Repair for the new generation of coupling heads with filter for trailers only with repair kit 952 201 920 2

The new generation of coupling heads with filter for trailers introduced in [Market Information 7016](#) (15 June 2007) must only be repaired using repair kit 952 201 920 2.

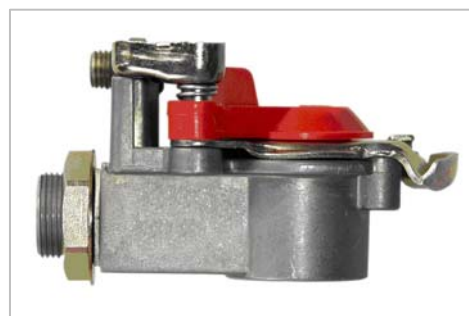
The repair kit will include 2 sealing rings with different contours.

For repair it is essential that you note the contour of the installed sealing ring and replace it with the identical spare part from the repair kit.

Installing an incorrect sealing ring will cause a malfunction of the braking system.

Until this repair kit is made available, the entire coupling head needs to be replaced if a problem occurs.
